SUBJECT: THREE MILE ISLAND, UNIT 1 (TMI UNIT 1)
OPERATING LICENSE NO. DPR-50
DOCKET NO. 50-289
EXIGENT TECHNICAL SPECIFICATION CHANGE REQUEST NO. 309 -
NUCLEAR SERVICES RIVER WATER SYSTEM

Technical Specification Change Request No. 309

TMI Unit 1 Technical Specification Change Request No. 309

Safety Evaluation and No Significant Hazards Consideration

SECONDARY & NUCLEAR
 SERVICES RIVER WATER SYSTEMS

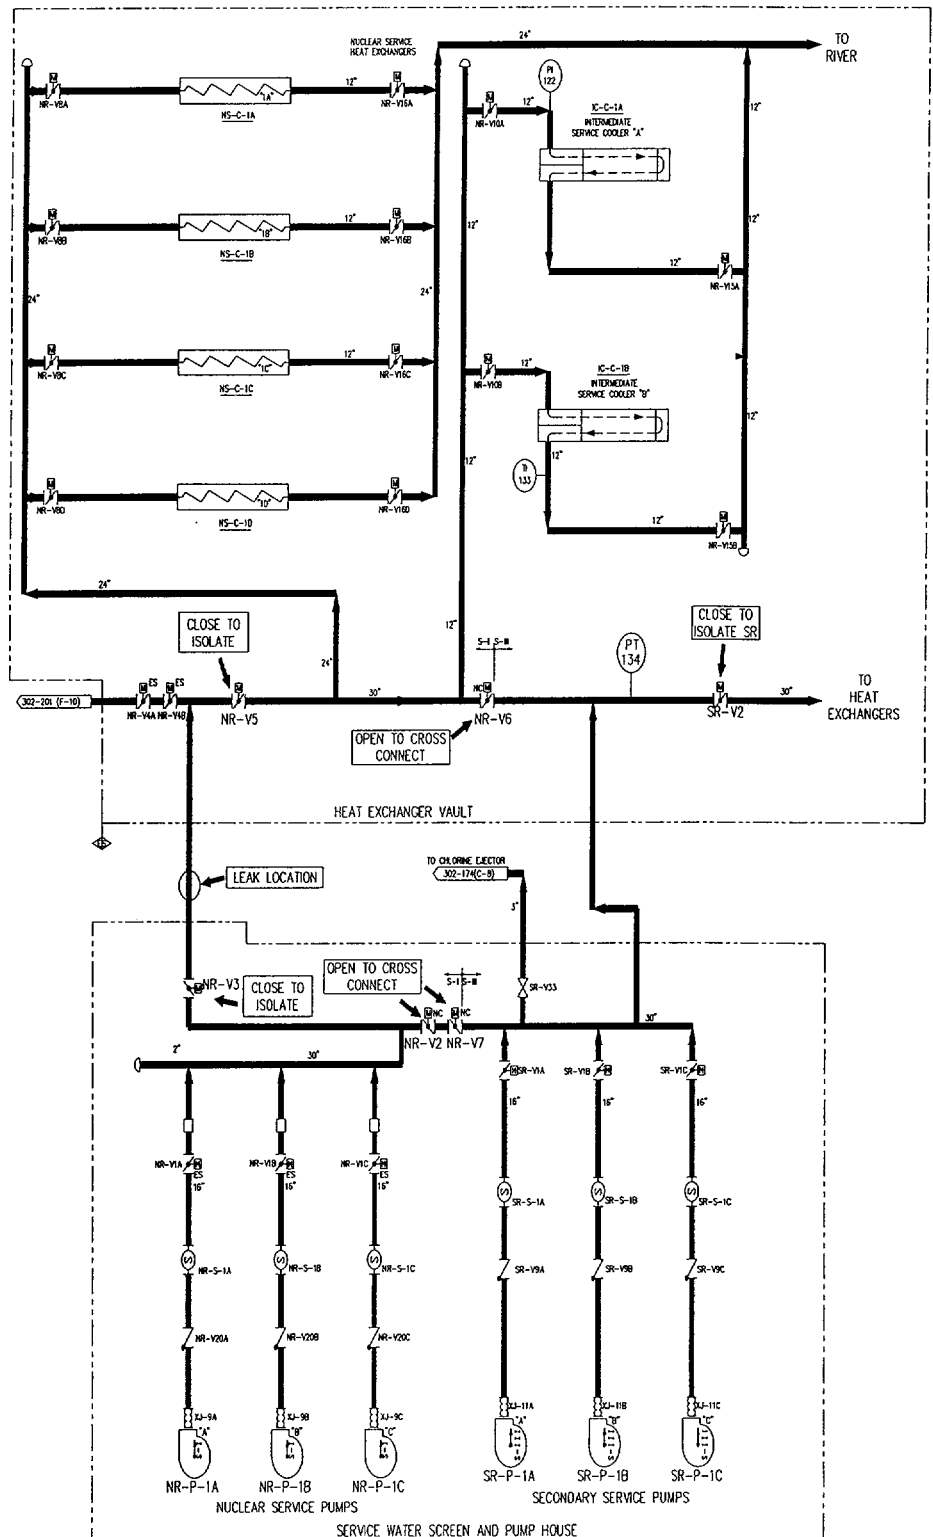
Prior to and during the repair, NR will be cross-connected to SR by opening NR-V-6, NR-V-2, and NR-V-7. The leaking line will be isolated by closing NR-V-3 and NR-V-5. Three NR and three SR pumps will be available. At least two pumps will be operating. Flow will then be provided through the SR underground piping to both SR and NR systems. Two NR pumps, powered from separate 1E buses, will be available to automatically start on Engineered Safeguards (ES) actuation. Attachment 2 shows the key portions of the system.
